<u></u>		<u>.</u>	(BW	ROG-65, Re	v. 0)	TSTF-353
Indus	stry/TSTF St	andard Tech	nical Spe	cification	Change Travele	r
P/T SRs during s	ingle loop operatio	on				
Classification: 1	Correct Specifica	tions				
NUREGs Affected	: 🗌 1430 🔲	1431 🔲 1432	1433	1434		
Description:						
Add two new SRs renumber followin	• • •	and 6) to P/T Lim	its Specificat	ion applicable	e during single loop oper	ations;
recirculation loop no limitations are limitations impose recommended by recirculation loops limits. This locati	operations, flow in provided. The limit d for the more seven GE and are imposed operating but are to	creases and/or pow itations of the prop- ere thermal transies d in several license more appropriately soults in applying th	ver increases osed SRs for nt of starting e's TS. Thes located in th	can result in s flow and/or p an idle pump se limits were e Specificatio	on loop. However, when imilar concerns for P/T ower increases are analor. These limitations have located in the CTS Spec on for Pressure and Temp I is consistent with the a	stresses, but ogous to the been bification for perature

TSTF-353

RCS P/T Limit B 3.4.10 {BWR/4} B 3.4.11 {BWR/6}

RCS P/T Limits TSTF 353,4,11 , Rev.D

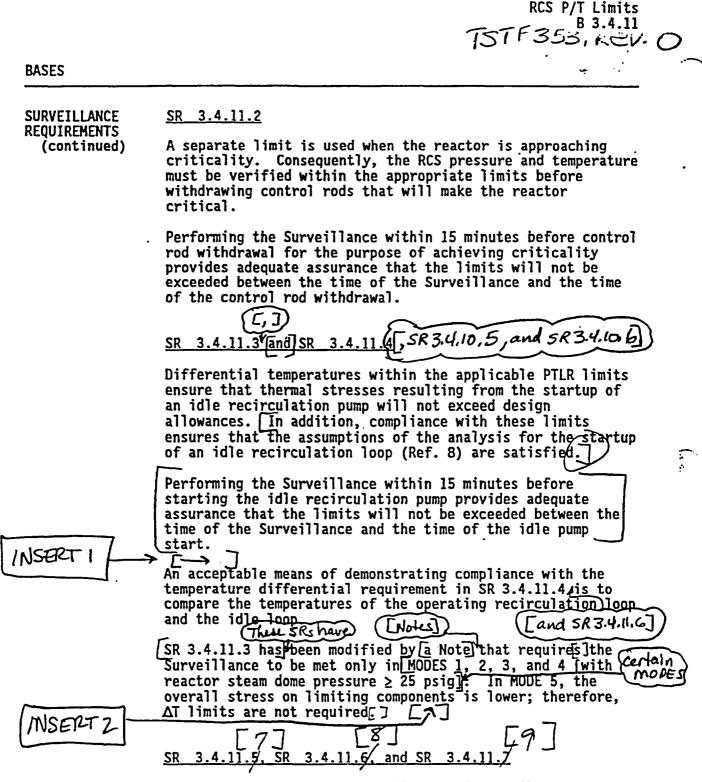
SUR	VEILLANCE RE	EQUIREMENTS (continued)	· · · · · · · · · · · · · · · · · · ·
		SURVEILLANCE	FREQUENCY
SR	3.4.11.3	Only required to be met in MODES 1, 2, 3, and 4 [with reactor steam dome pressure \geq 25 psig].	
		Verify the difference between the bottom head coolant temperature and the reactor pressure vessel (RPV) coolant temperature is within the limits specified in the PTLR.	Once within 15 minutes prior to each startup of a recirculation pump
SR	3.4.11.4	Only required to be met in MODES 1, 2, 3, and 4.	
ISE	RT >	Verify the difference between the reactor coolant temperature in the recirculation loop to be started and the RPV coolant temperature is within the limits specified in the PTLR.	Once within 15 minutes prior to each startup of a recirculation pump
SR	3.4.11.8 [7]	Only required to be performed when tensioning the reactor vessel head bolting studs.	
		Verify reactor vessel flange and head flange temperatures are within the limits specified in the PTLR.	30 minutes
